DUKE POWER COMPANY

Re: McGuire Nuclear Station  
Docket Nos. 50-369, 50-370

APPENDIX R

RESPONSE TO ENCLOSURE 2 OF SEPTEMBER 9, 1981 MEETING WITH NRC CONCERNING THE  
STANDBY SHUTDOWN SYSTEM

FIGURE 1

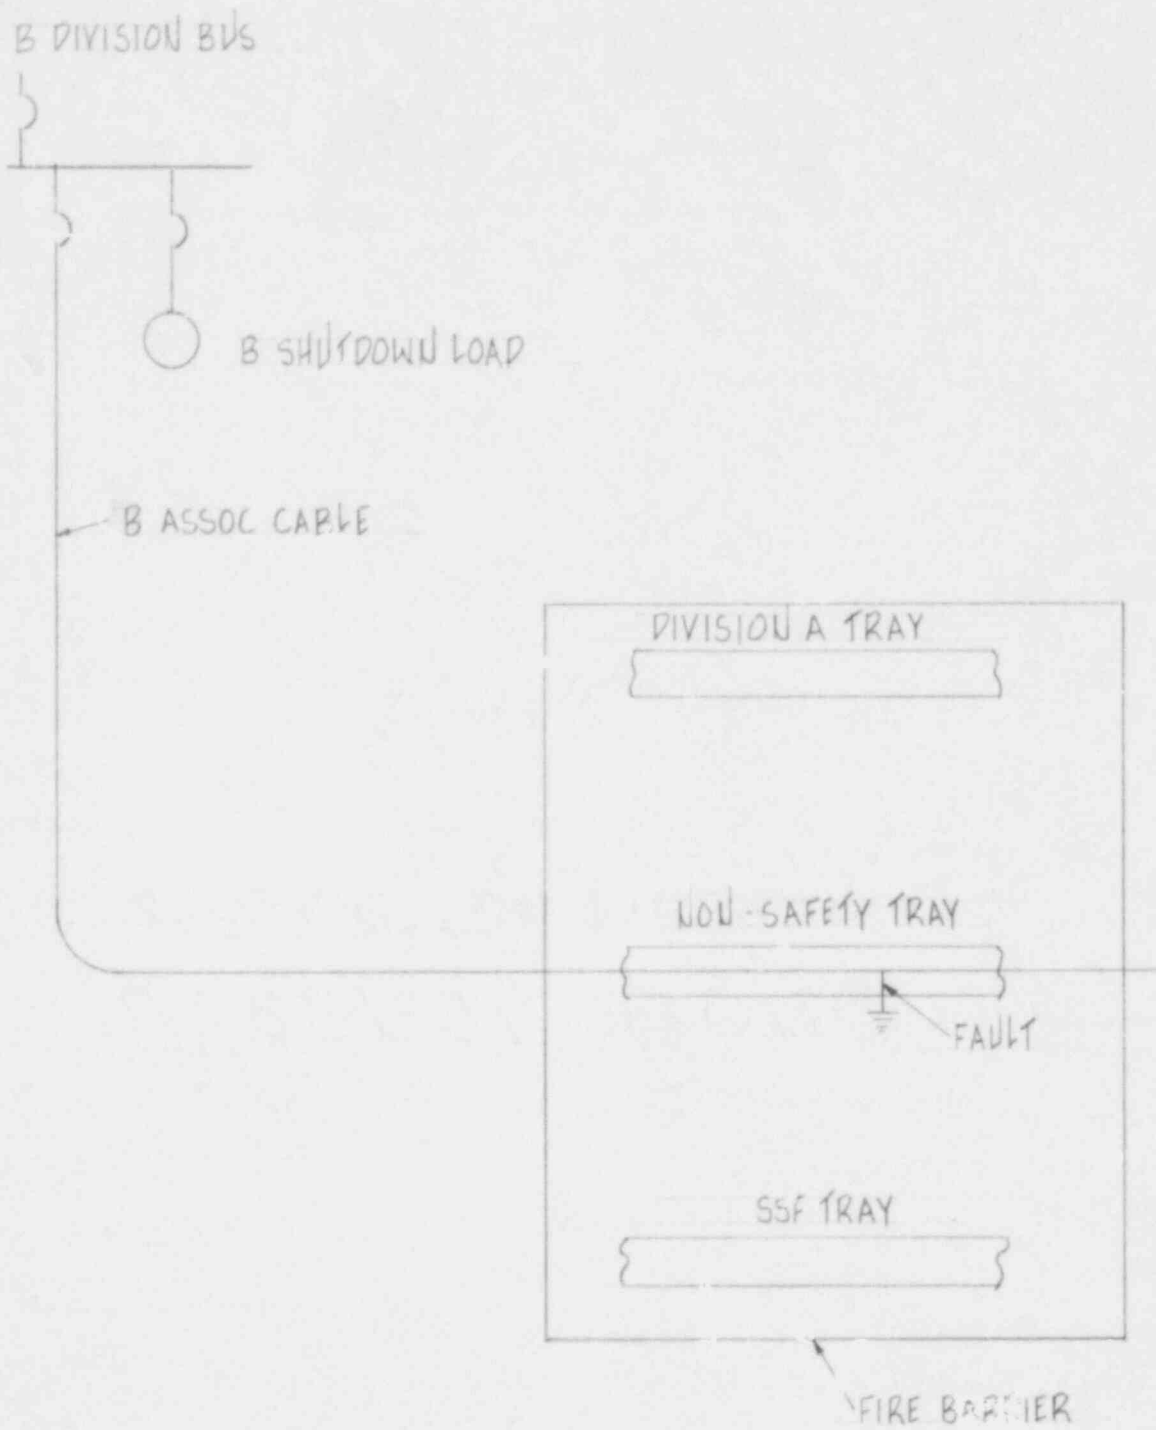
A fire zone was postulated which contained both Division A and Standby Shutdown Facility (SSF) shutdown cables. By the Duke criteria Division B Shutdown cables would not be present in this fire zone. However, the criteria does not prohibit Division B associated cables (which are connected to the Division B power busses) from being present in the subject fire zone. (See Figure 1 for pictorial representation)

For the case of an all consuming fire in the fire zone no degradation of the Division B shutdown division would occur since the associated circuit breaker (or fuse) will operate to clear the fault provided this breaker is coordinated with the bus incoming breaker. This breaker coordination is provided as part of the Duke design.
